Subject: Milestone Materials, Rochester Sand and Gravel-N. Quarry

RE: Milestone Materials, Rochester Sand and Gravel – North Quarry Project  
Environmental Assessment Worksheet (EAW)

# Environmental Assessment Worksheet Review: Milestone Materials North Quarry Project Area and DWSMA Vulnerability

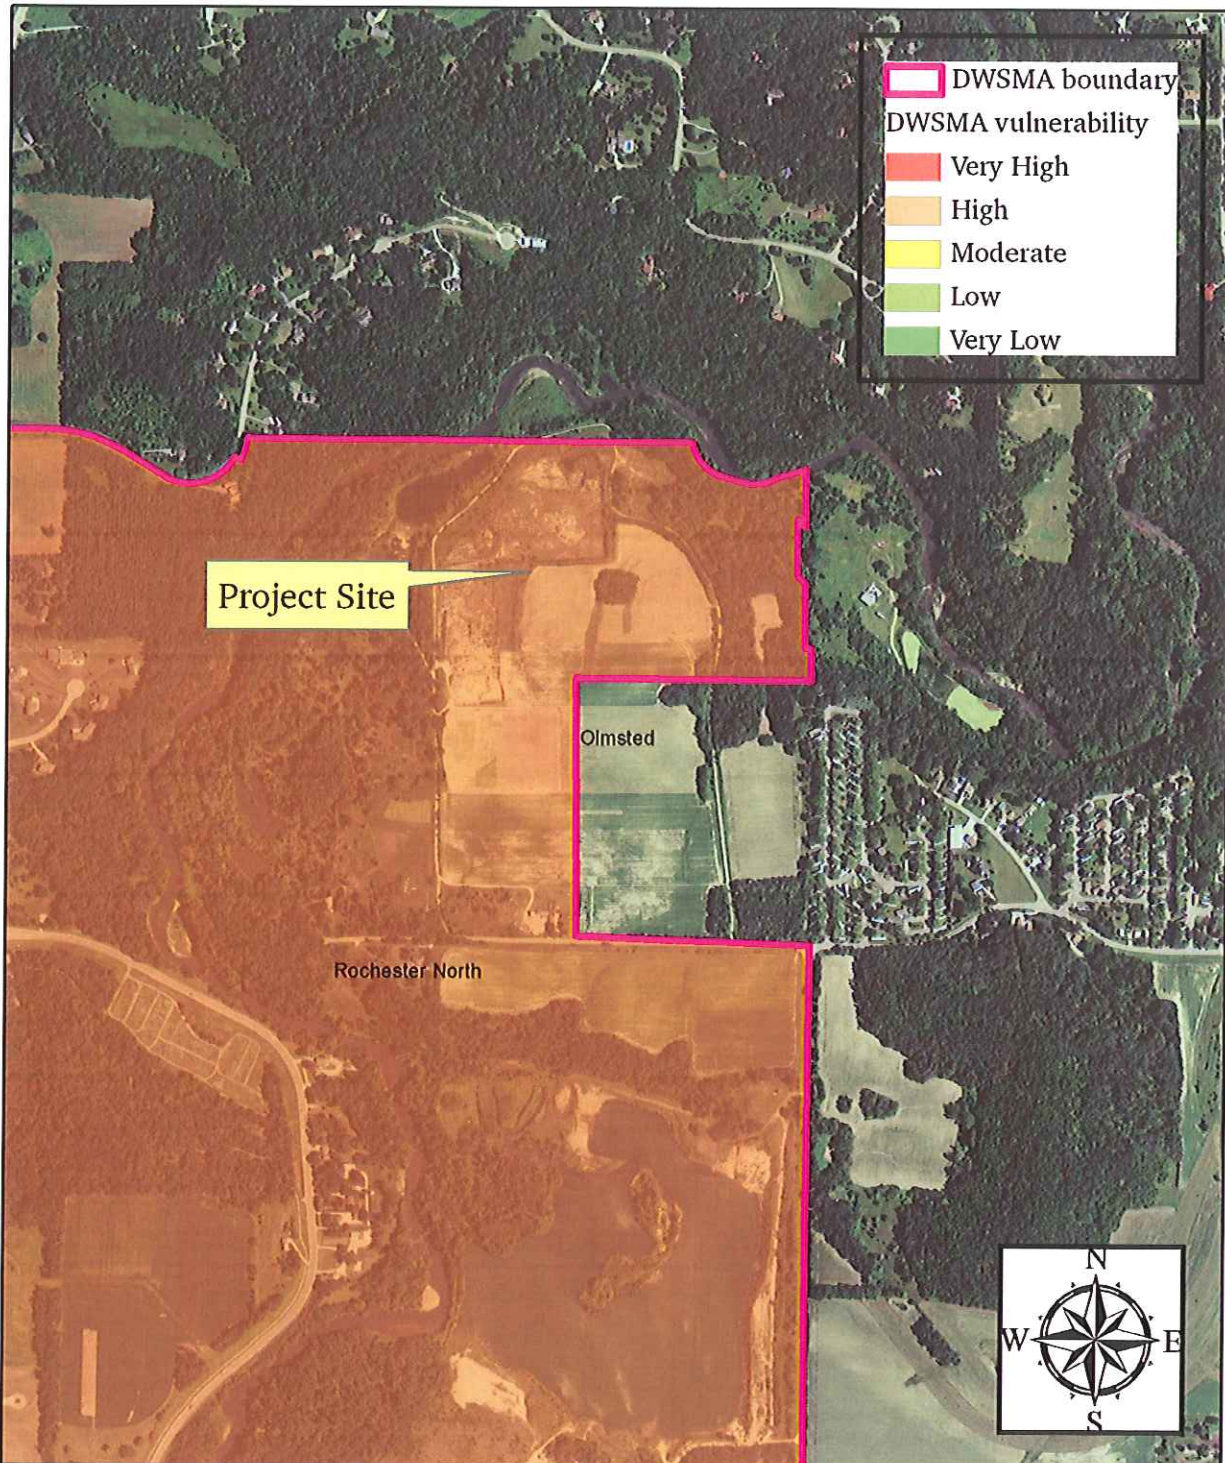
The project area overlaps highly vulnerable portions (see attached figure) of the existing Rochester North Drinking Water Supply Management Area (DWSMA). Because the project site is located over highly vulnerable portions of the DWSMA, please carefully plan project activities to avoid unnecessary contamination of the drinking water supply. I enclose "Wellhead Protection Issues Related to Mining Activities" for your consideration.
